Jones Gillam Renz Architects

Addendum #2: 9-27-23

Reserves at Magnolia – New Apartment Complex – Proj 21-2305

A STONE VENEER PLANTER SECTION

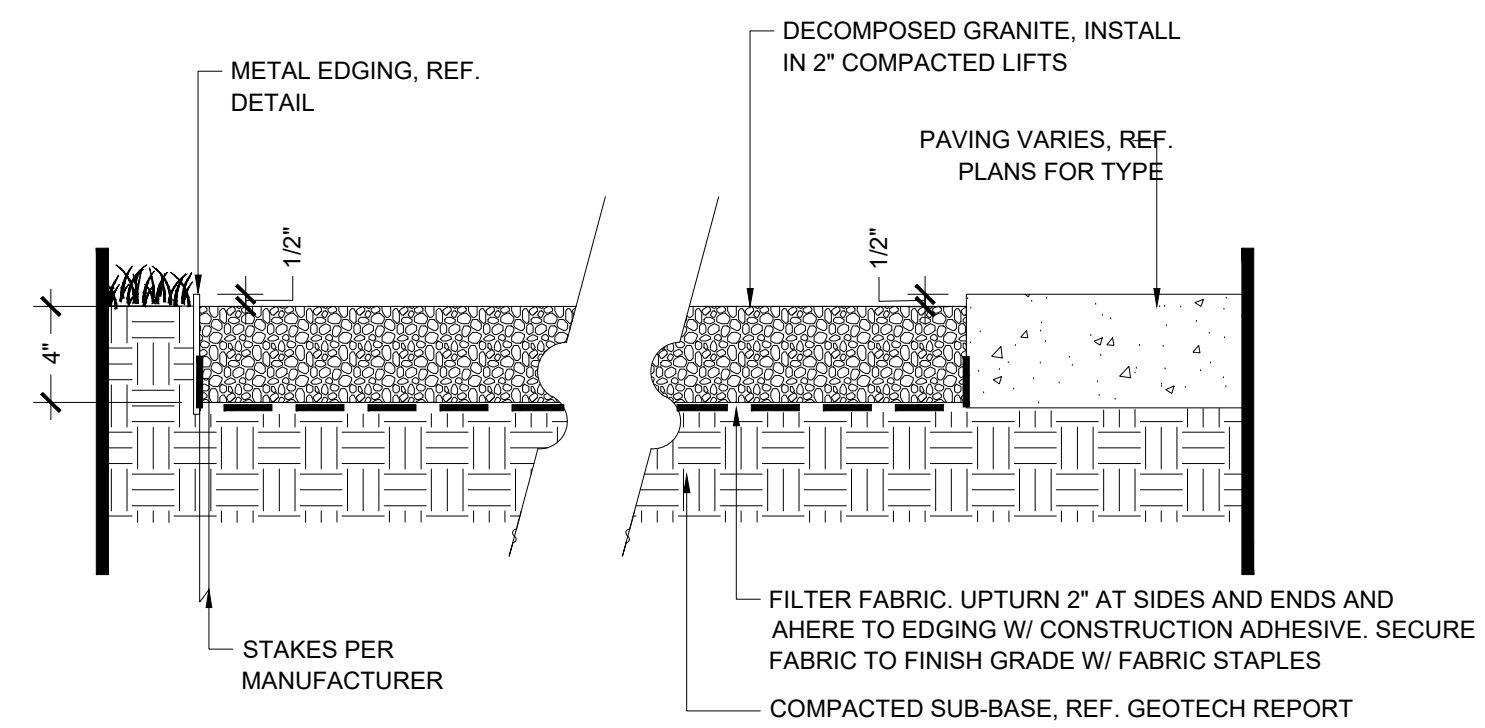
4. C11.3 – Clarification: Painting of the CMU instead the dumpster enclosure is not required. Gate pickets are not required to be stained.
5. L1.00
 - a. Raised Planter details have been added. Reference attached Landscape Sheet RFI#1.
